RE: Work Plan - Subsurface Investigation  
1549 32<sup>nd</sup> Street, Oakland, California  
*ACC Project No. 6875-001.01*

**WORK PLAN  
ADDITIONAL SUBSURFACE SOIL AND  
GROUNDWATER INVESTIGATION**

**1549 32<sup>nd</sup> Street  
Oakland, California**

*ACC Project Number: 6875-001.01*

Figure Number: 2

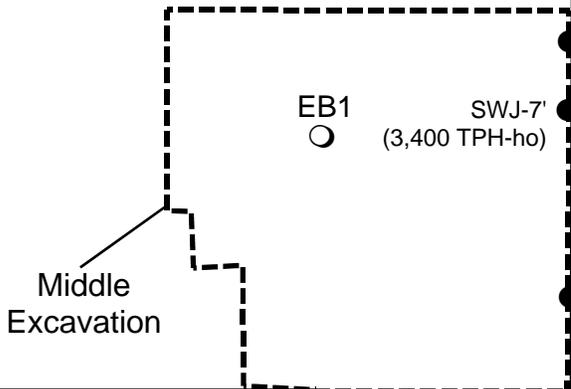
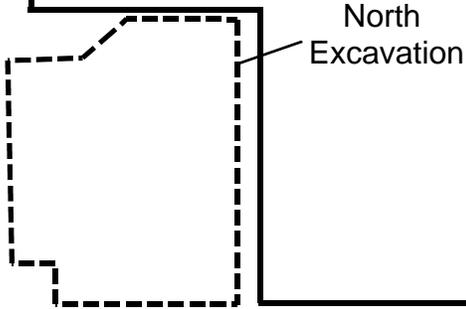
### ***Technical Comment 2 – Off-Site Characterization***

ACC proposes to advance one continuously-cored soil borings (EB 4) in the immediate vicinity of soil boring B-18 and one soil boring (EB 5) in the approximate center of the property at 2668 Hannah

ACC proposes to advance one continuously-cored soil boring (EB 2) in the immediate vicinity of soil boring B-9 and one soil boring in the immediate vicinity of soil sample SWJ-7' (EB 3), log the soil borings to a minimum depth of 12 feet bgs, and collect one to two soil samples in each soil boring for analysis of TEPH and VOCs. The primary goal of soil borings EB 2 and EB 3 is to directly observe the soil type, characterize soil for suspect constituents of concern and compare soil and groundwater analytical results with those reported by ERAS and Environmental Restoration Services. Proposed soil boring locations are shown on Figure 2.

Street, log and screen the soil borings for volatile constituents to a minimum depth of 12 feet bgs with a PID, and collect one soil sample and one grab groundwater sample in each soil boring for analysis of TEPH and VOCs. The primary goal of these two soil borings is to directly observe the soil type, characterize soil for suspect constituents of concern and further confirm analytical results reported by ERAS and Environmental Restoration Services.
